1125-012

November 20, 1997

**Re: US Army Corps of Engineers (USACOE), Prospect Island Project
DRAFT Modification Report**

McDONALD ISLAND
NOVEMBER 1994

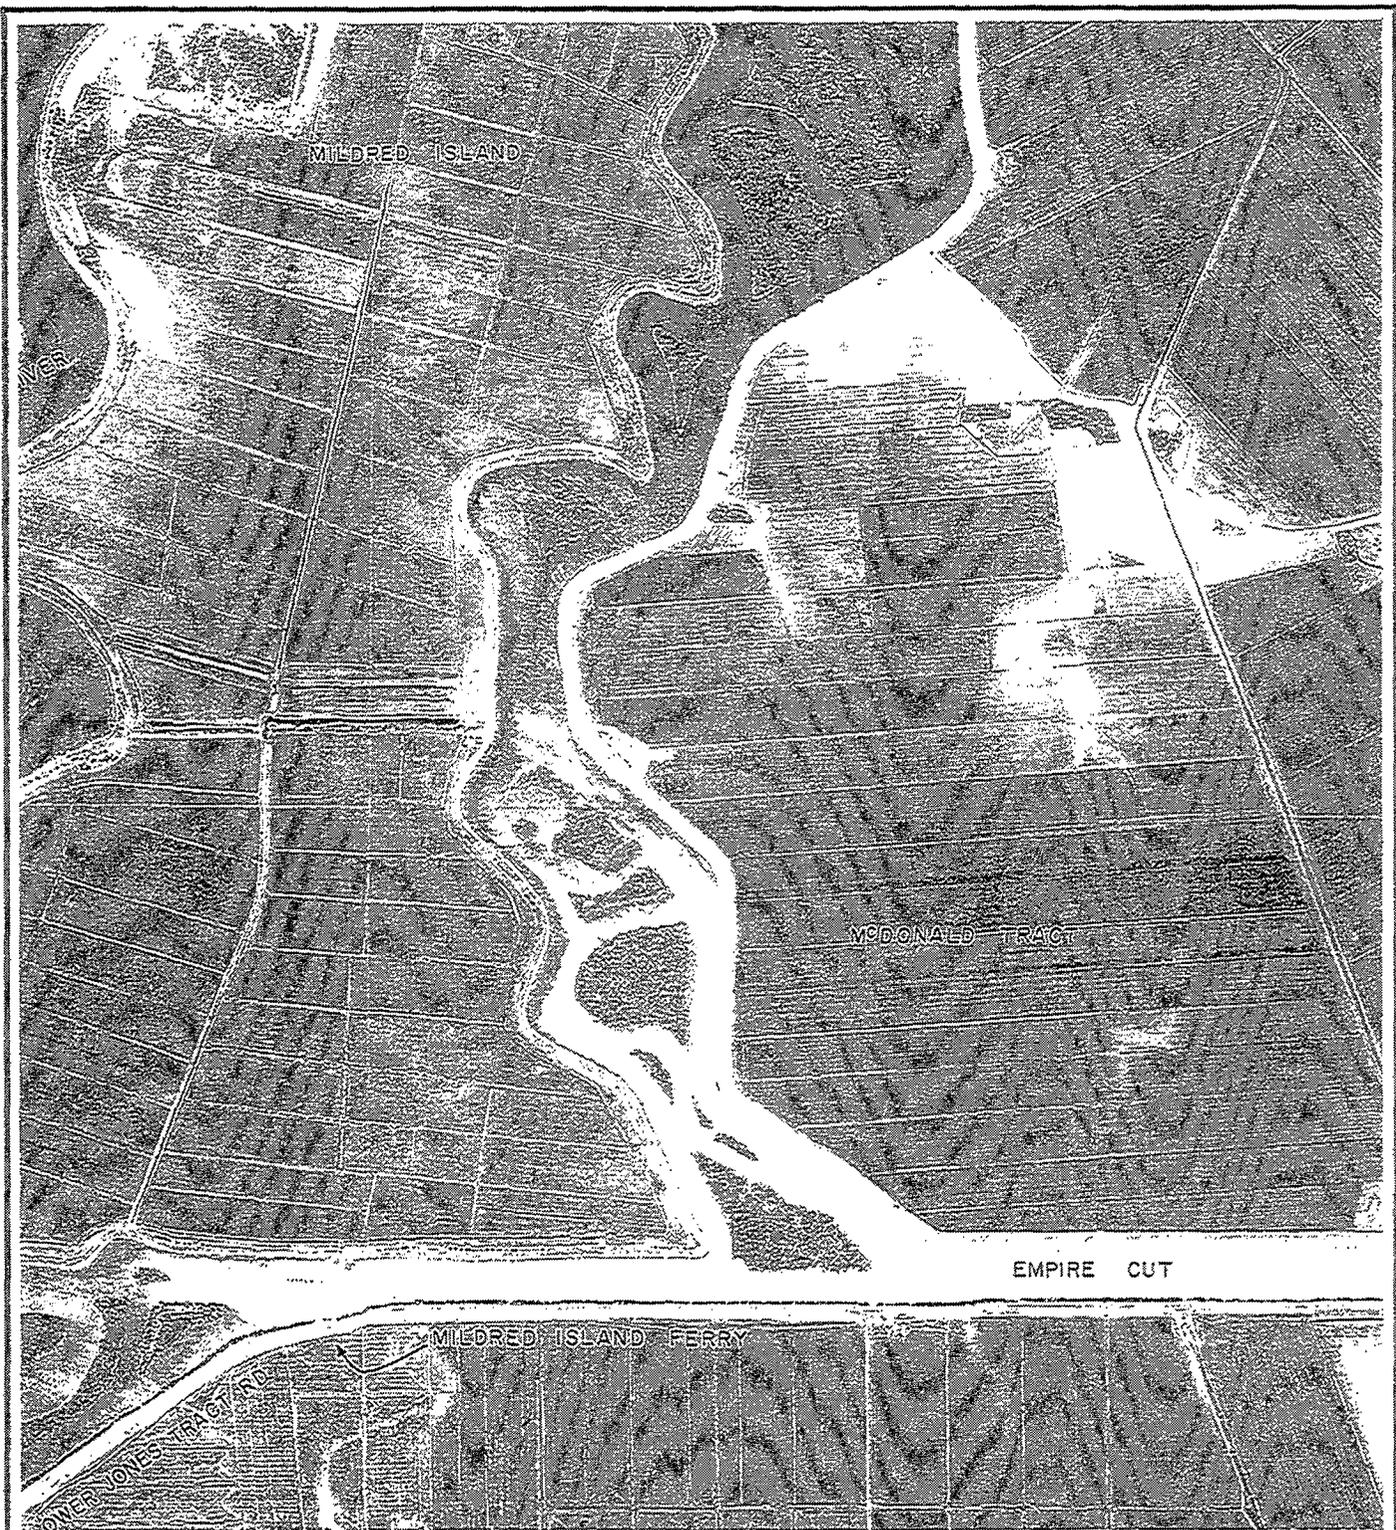
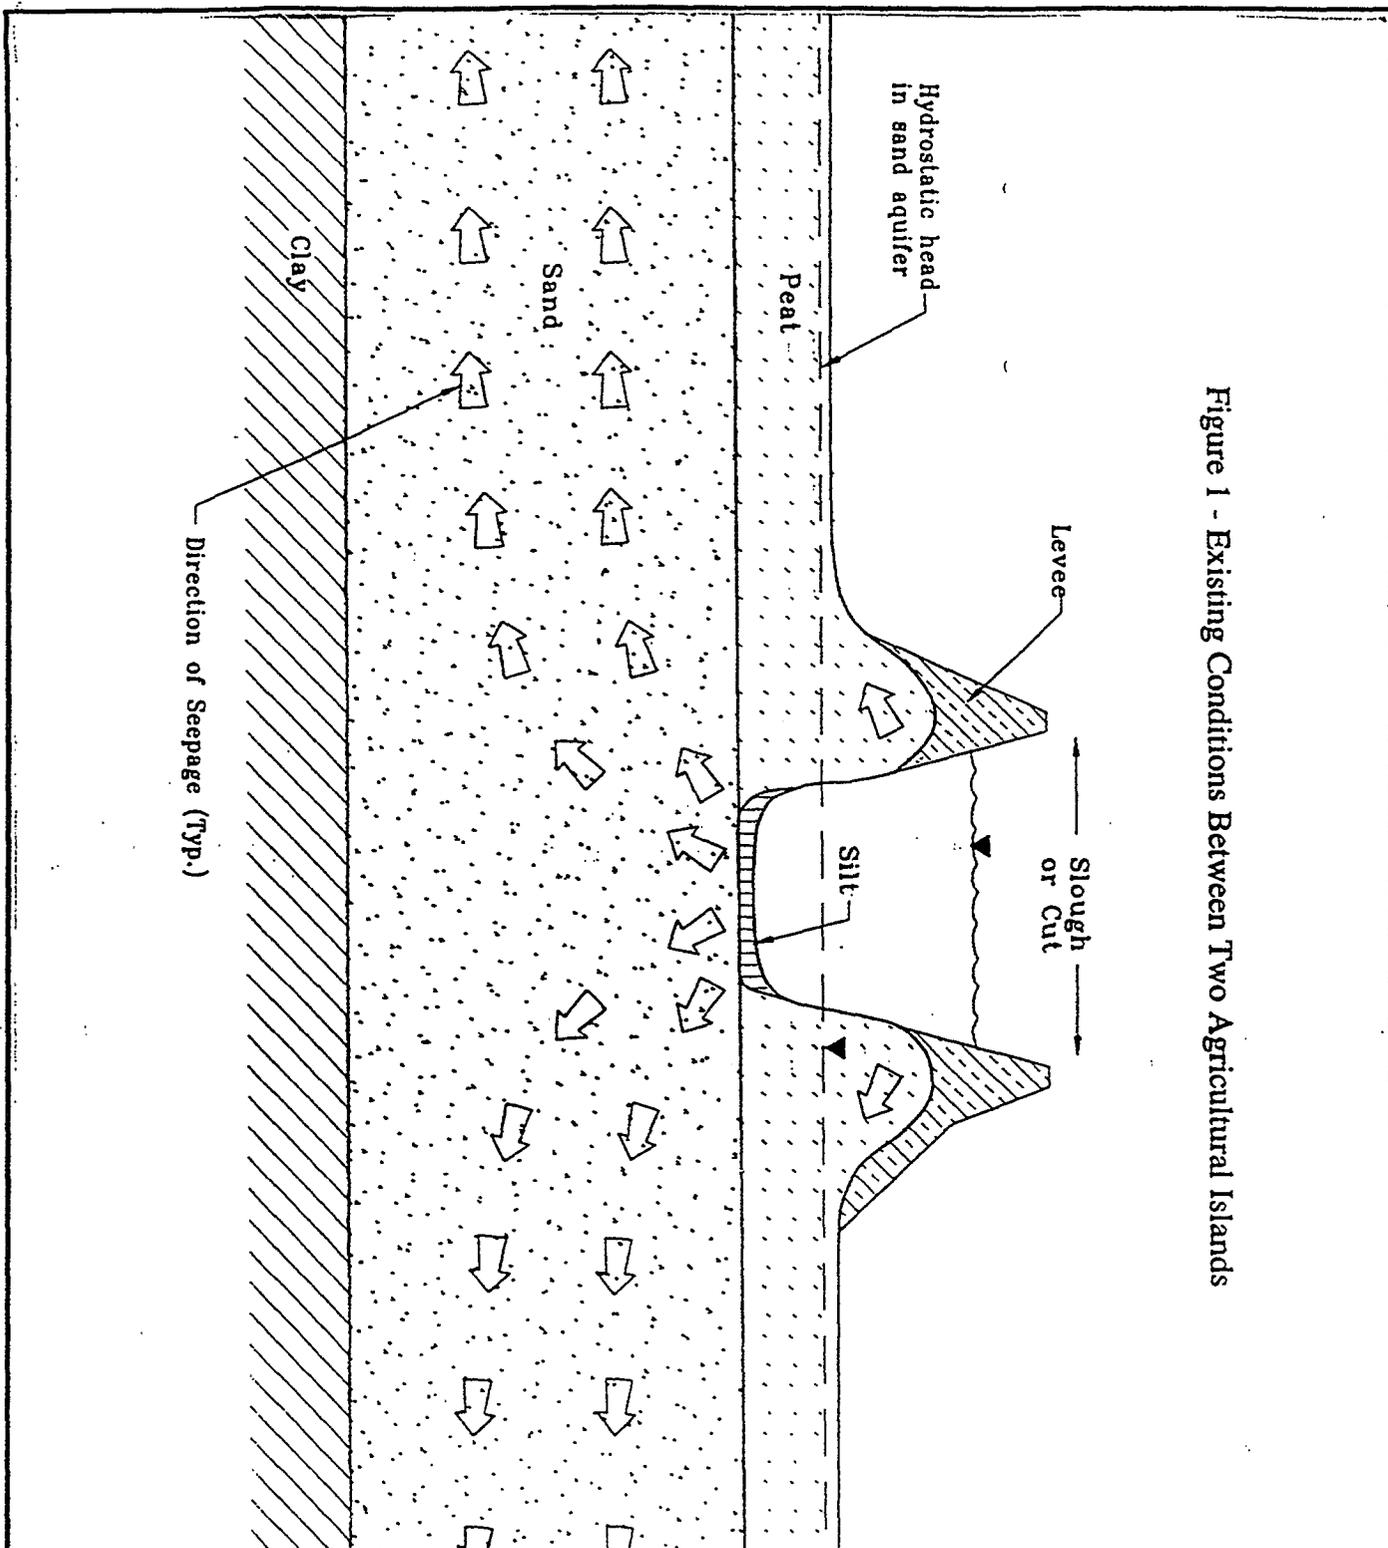
A historical example of this is the Mildred Island flood in 1983. The neighboring McDonald Island, experienced a significant increase in seepage along the adjacent levee. This increase in seepage resulted in a saturated levee foundation and unfarmable fields along the side adjacent to Mildred Island. I have enclosed two photographs depicting the before and after condition on McDonald Island in order to demonstrate this seepage phenomenon. You will note that in the 1963 photo, the fields along the west side of McDonald, adjacent to Mildred, extend all the way to the toe of the levee. In the 1994 photo, the condition is significantly different, and a band of unfarmable ground lies between the toe of the levee and where the fields start due to the extensive seepage.

Figure 1 - Existing Conditions Between Two Agricultural Islands

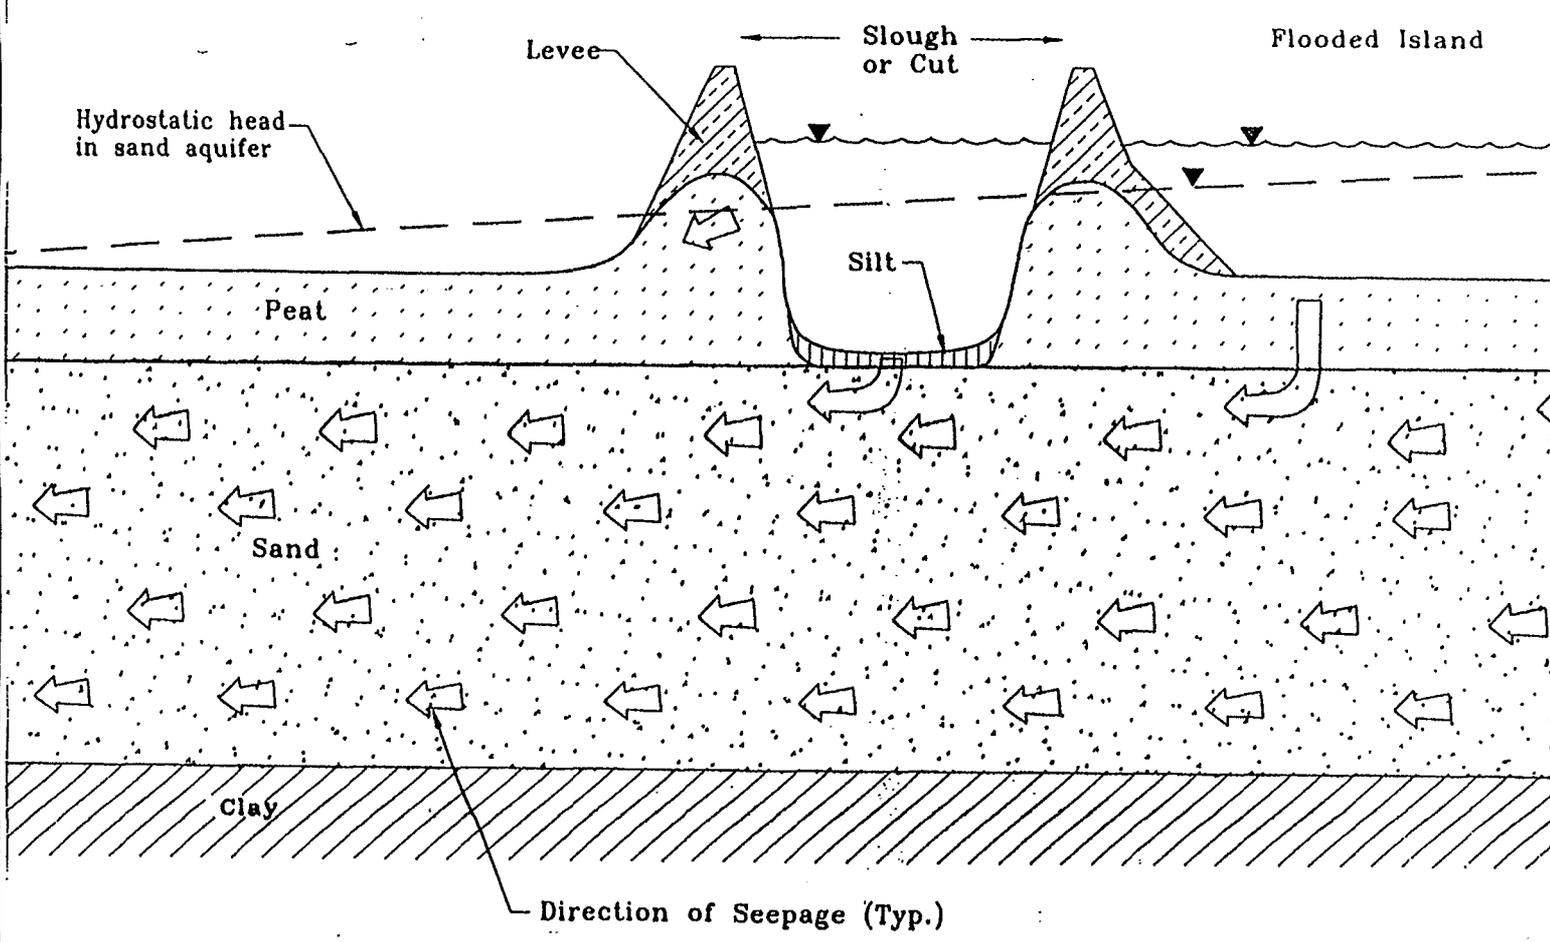
Increased seepage has been demonstrated on numerous occasions in the past where delta islands flood, and portions of the levee systems and farming fields on adjacent islands become saturated. This phenomenon can be better illustrated on the attached figures. **Figure 1** is an example of what the current conditions are between Ryer and Prospect, whereas, Prospect is dry and the seepage can be attributed to Miner Slough. **Figure 2** demonstrates what occurs when a flooded island is adjacent to a nonflooded island and how the seepage transmits subterranean or beneath the slough and levee and surfaces behind the levee.

Identification of the existing problem which is the first element of a monitoring must take into account both the high seepage that passes through or immediately beneath the levee embankment (Fig. 1) as well as deep seepage which passes through more permeable materials below the peat that underlies the levee embankment (Fig. 2). Runoff generated from high seepage will be handled as it usually is through the District's existing collection and conveyance system as part of the District's overall drainage system. Subsurface sand layers, however, provide the primary conduits for deep seepage. These layers permit the seepage to travel from a flooded island onto an adjacent island. Accurate identification of the pre and post site conditions for use in analyzing the potential for seepage include but are not limited to investigation and measurement techniques such as:
